HEAVY VEHICLE LOCAL ROAD REPORT

Sydney Metro West – Western Tunnelling Package

Clyde/ Rosehill

Document Title	Clyde/ Rosehill Heavy Vehicle Local Road Report
Project Name	Sydney Metro West – Western Tunnelling Package
Client	Sydney Metro
Document Reference No.	SMWSTWTP-GLO-CLJ-HS-RPT-000001-D.01
Revision Date	7 June 2022

CLY-SPA-01

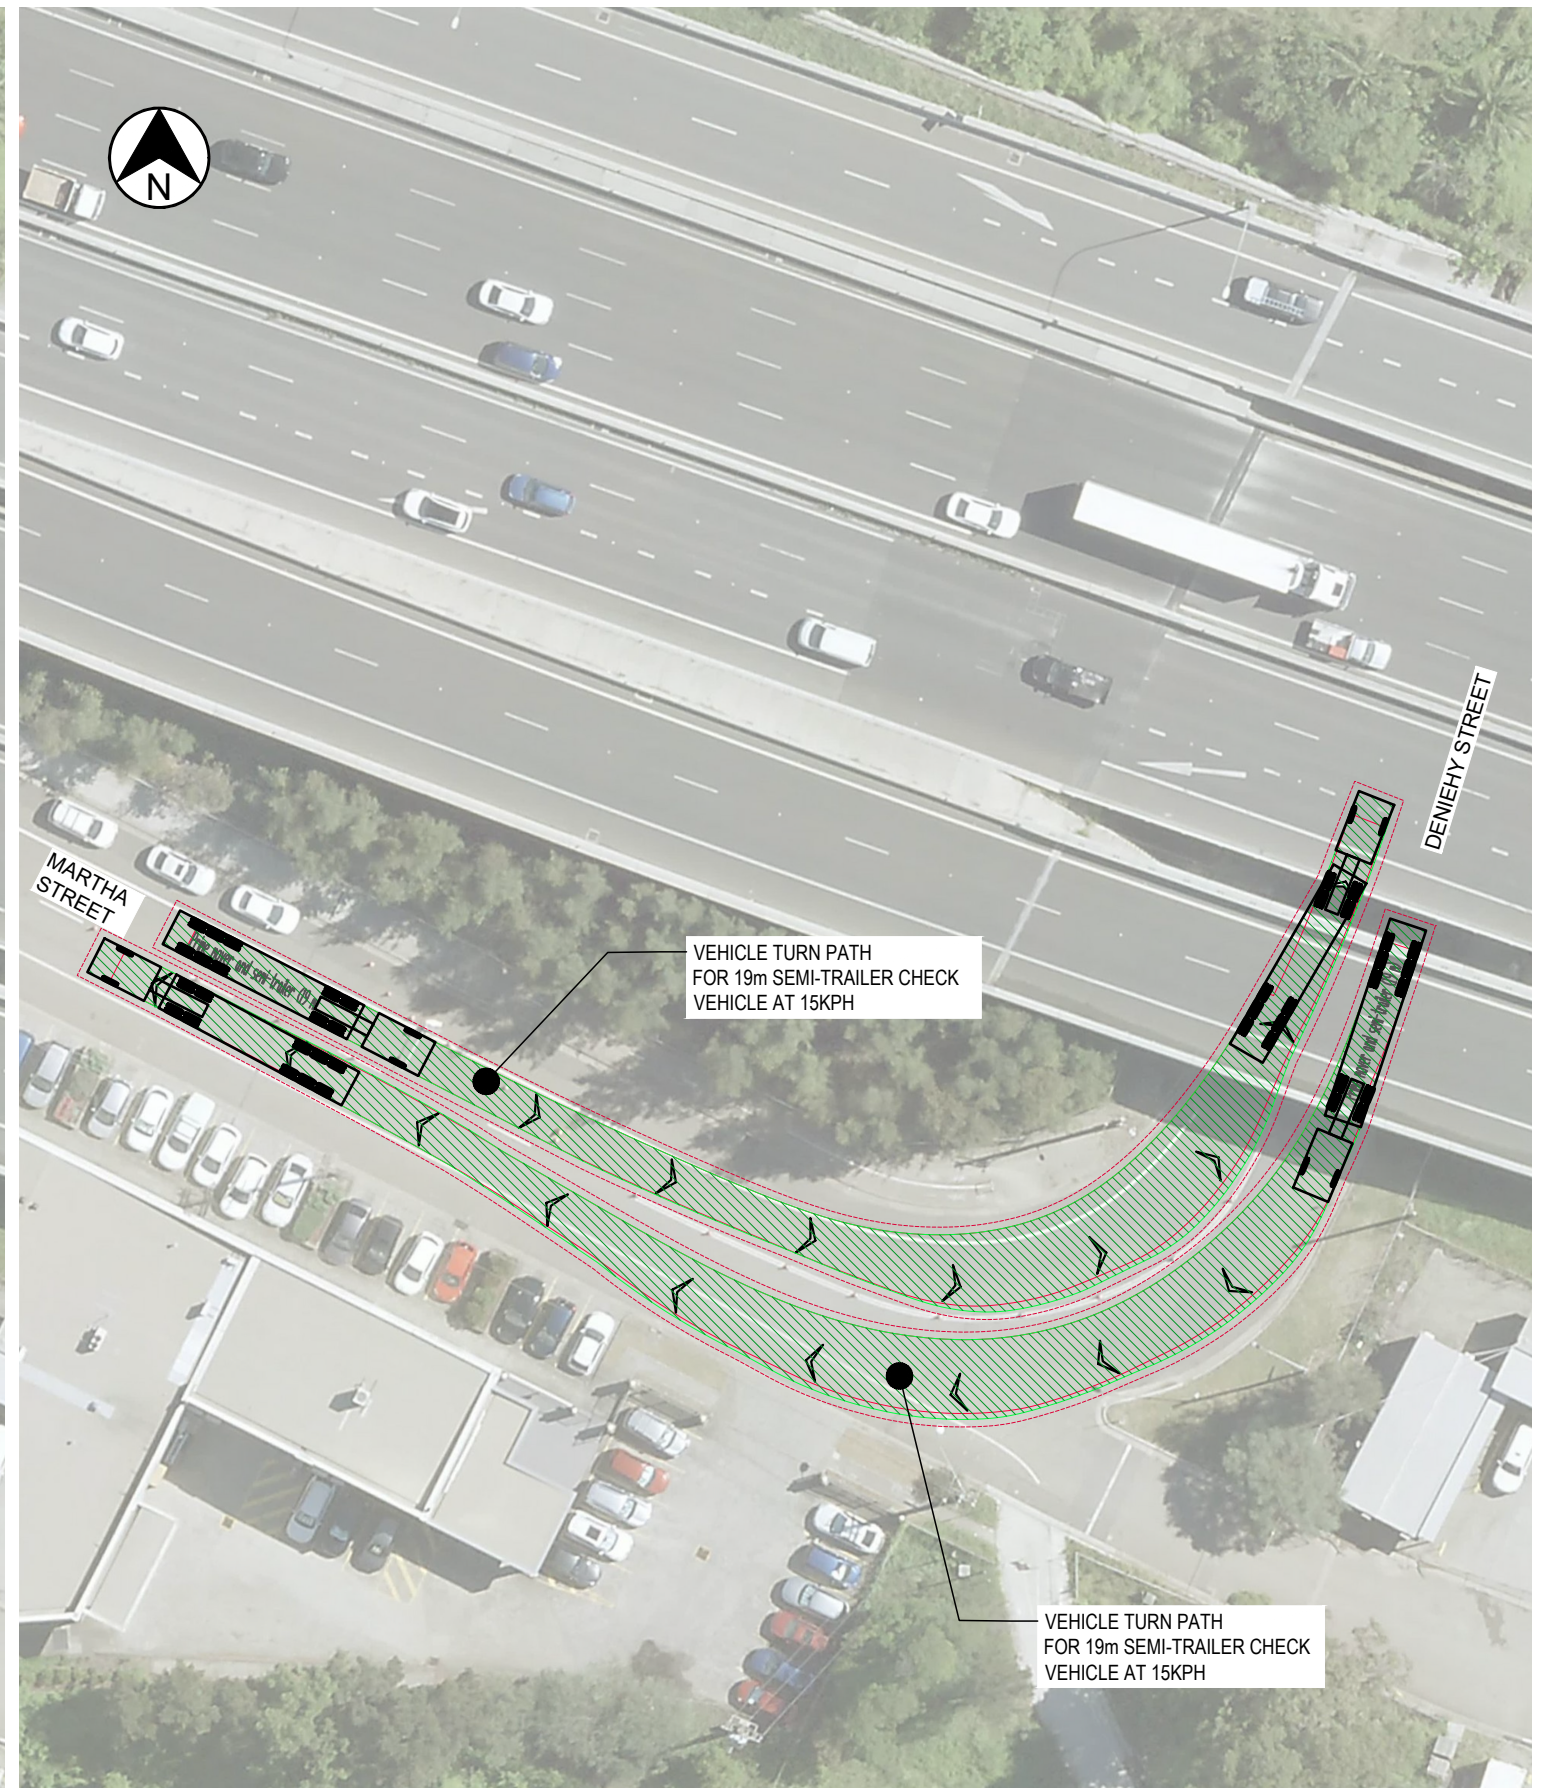
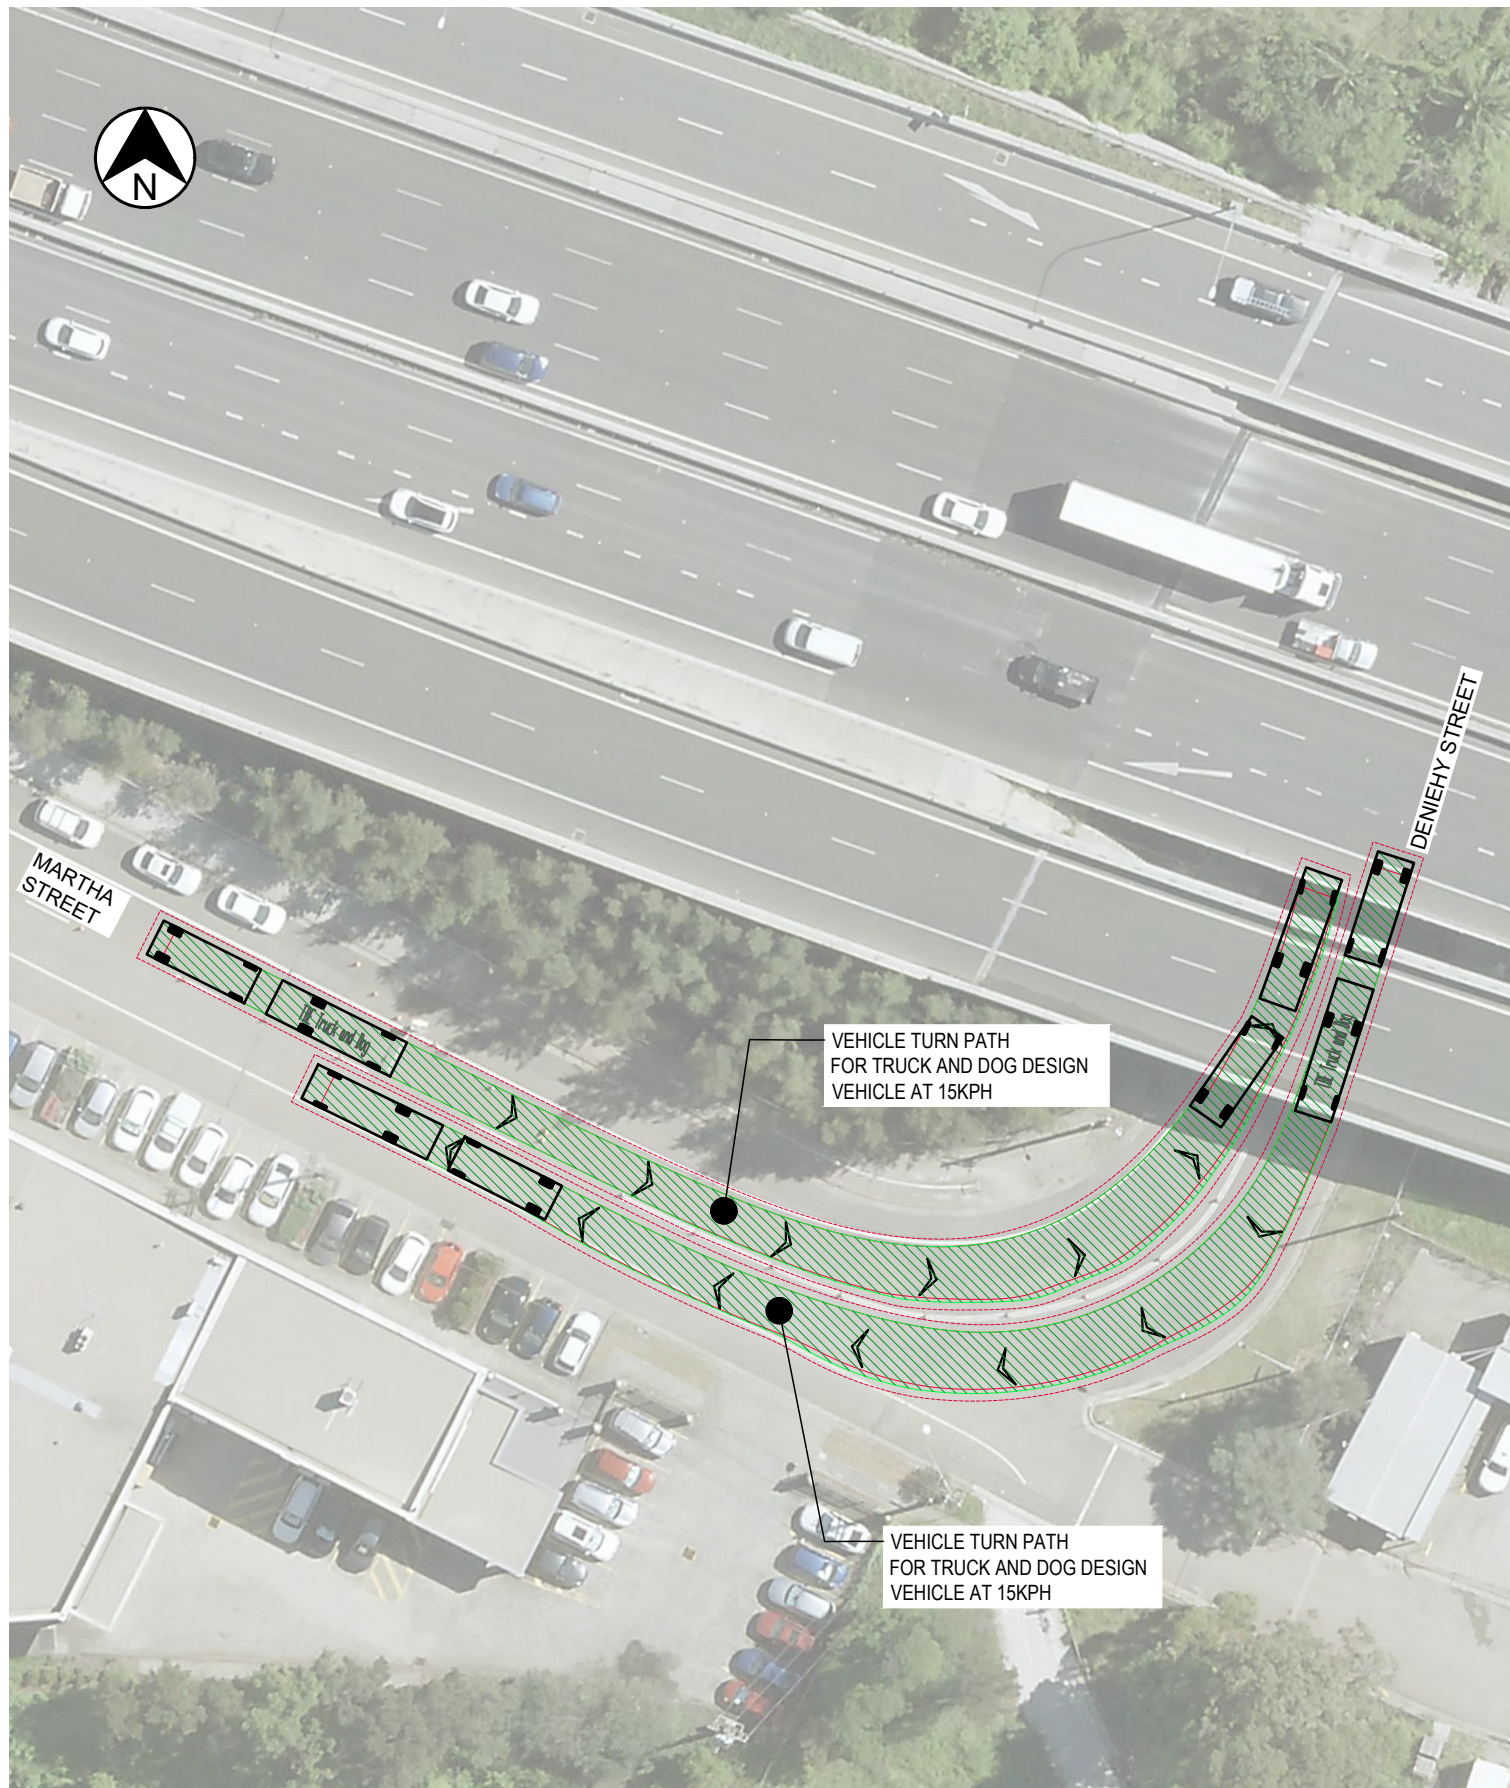
- Unwin Street onto Shirley Street;
- Martha Street onto Wentworth Street.

CLY-SPA-03

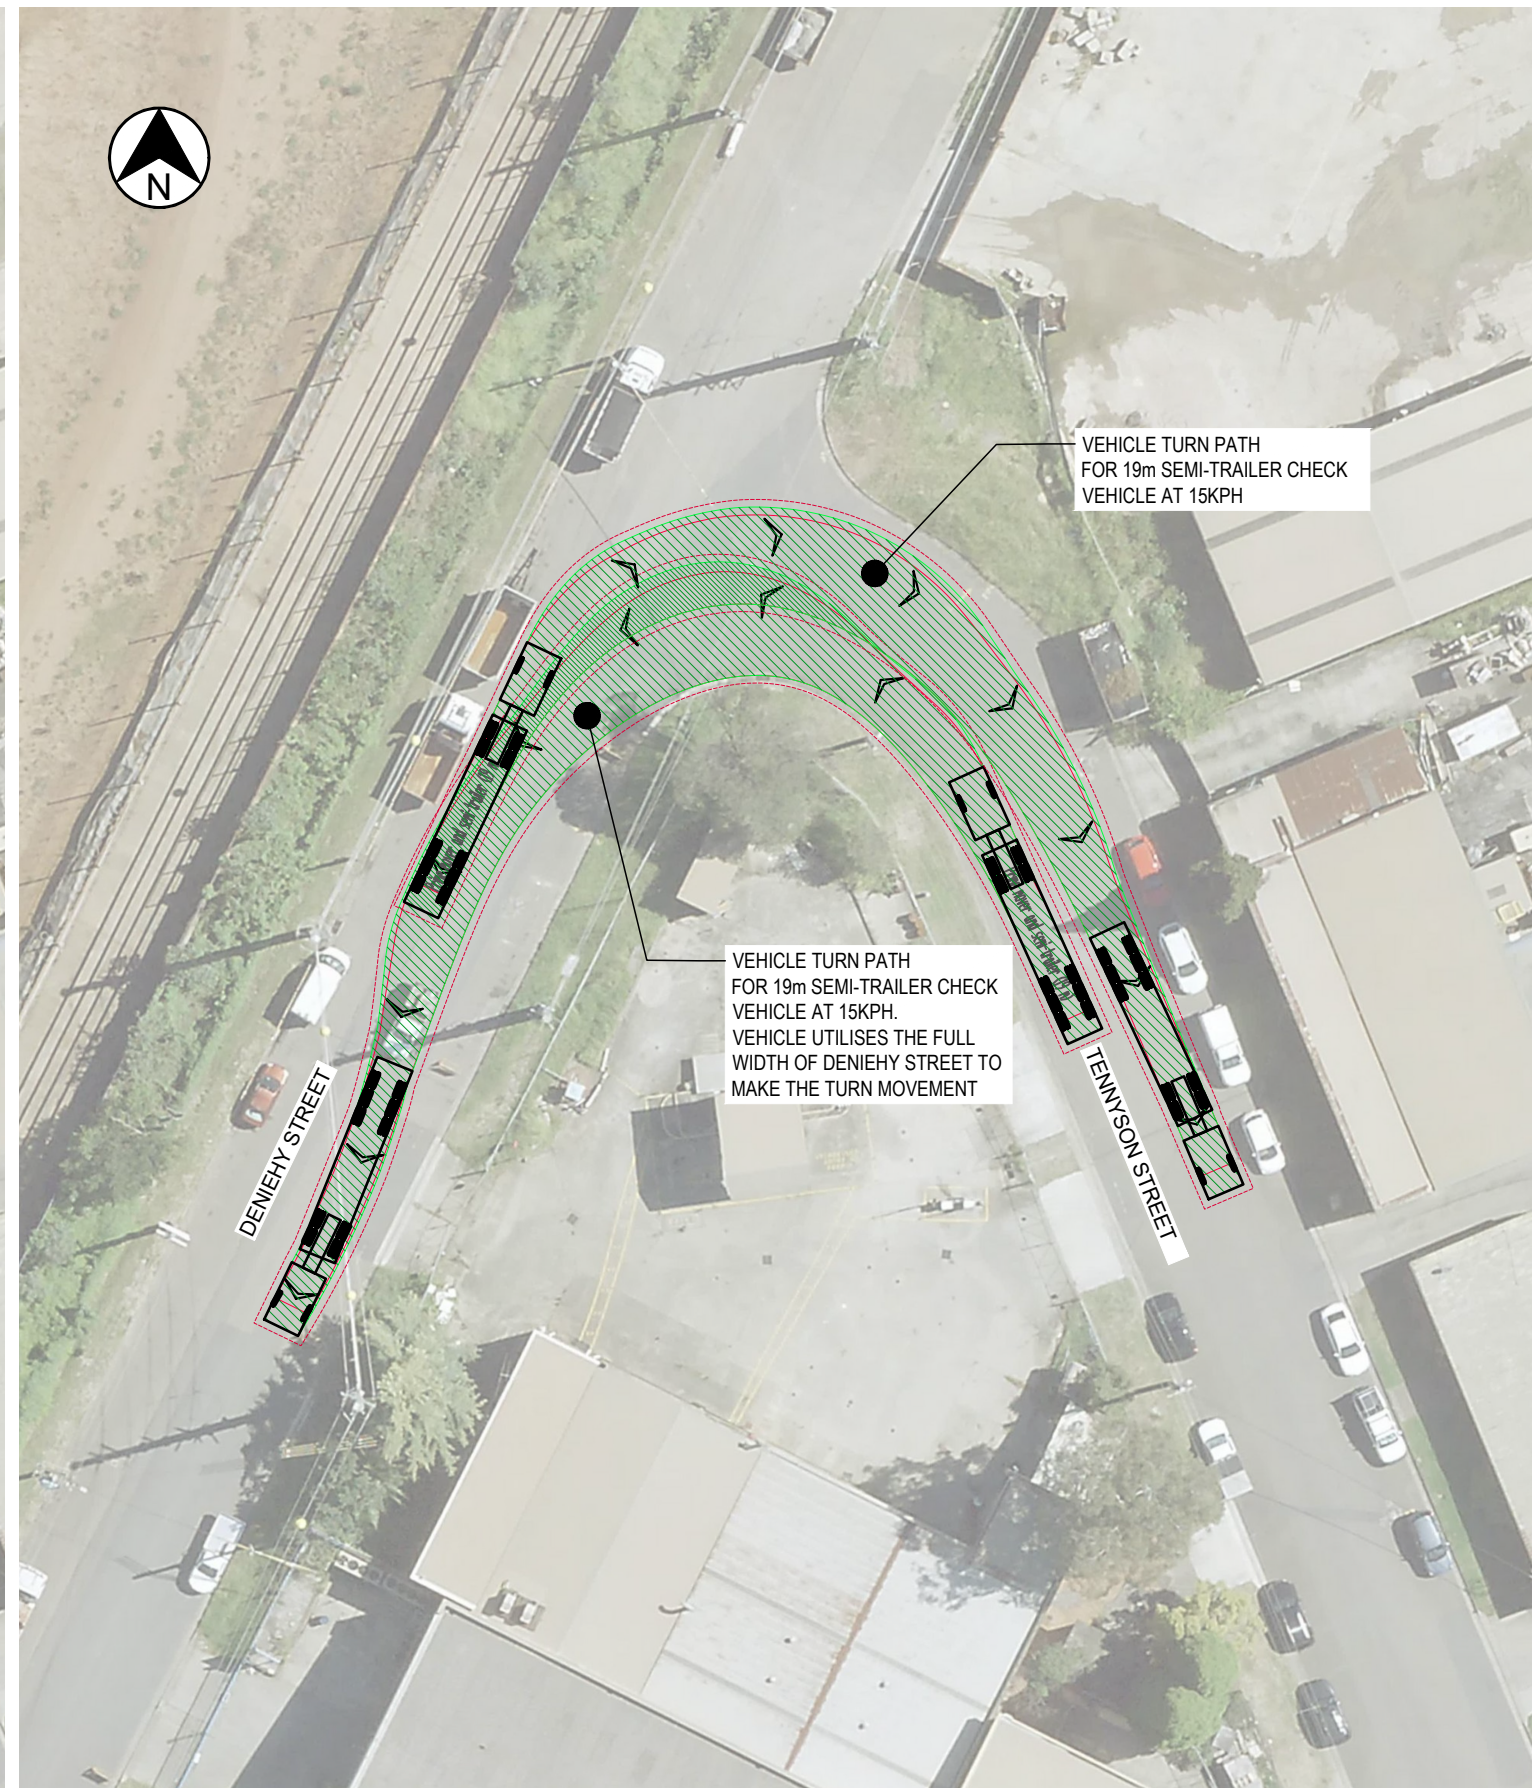
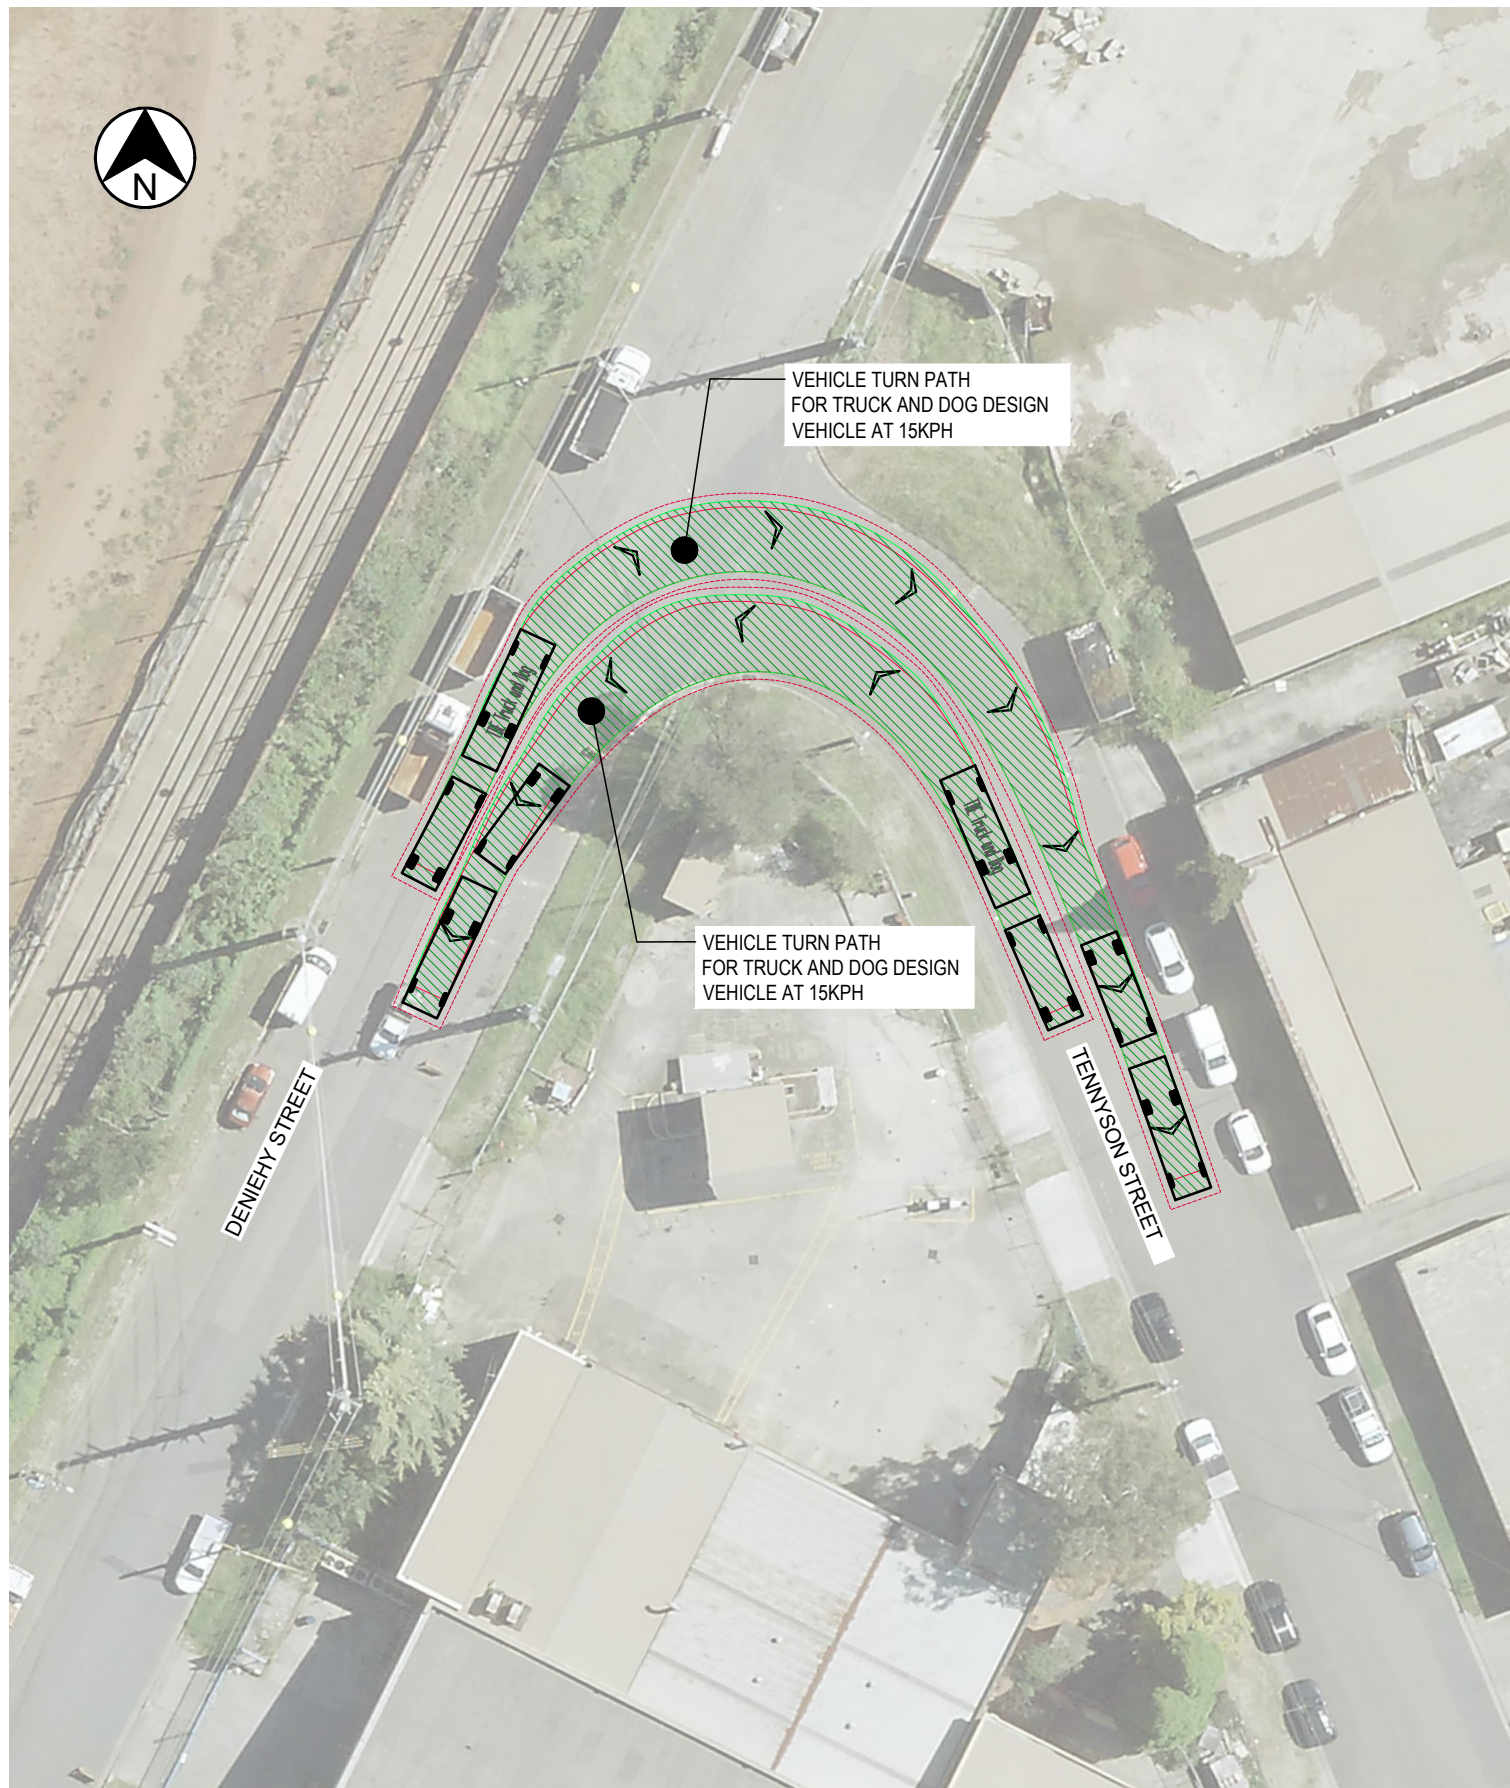
04.01	17/05/2022	GLO	SBESIM	SMWSTWTP-GLO-CLJ-HS-RPT-000001-B.01	Table 6	tba	The swept paths are provided in Appendix A. Concurrent swept paths are shown at all locations. All swept paths are suitable other than as noted in the report	Observation	Y
								SMWSTWTP-GLO-CLJ-HS-RPT-000001-B.01	Table 6	tba		Observation	Y
				05	27/04/2022	TFN	LWILBY	SMWSTWTP-GLO-CLJ-HS-RPT-000001	Appendix A Swept Path Analysis - CLY-SPA-03	NA	The swept path for semi trailer movements between Deniehy St and Tennyson St show significant encroachment into the oncoming traffic lane on a tight bend. Please confirm how these movements will be managed to reduce the risk of collision with other heavy vehicles or road users.	Observation	Y
								SMWSTWTP-GLO-CLJ-HS-RPT-000001	Appendix A Swept Path Analysis - CLY-SPA-03	NA		Observation	Y
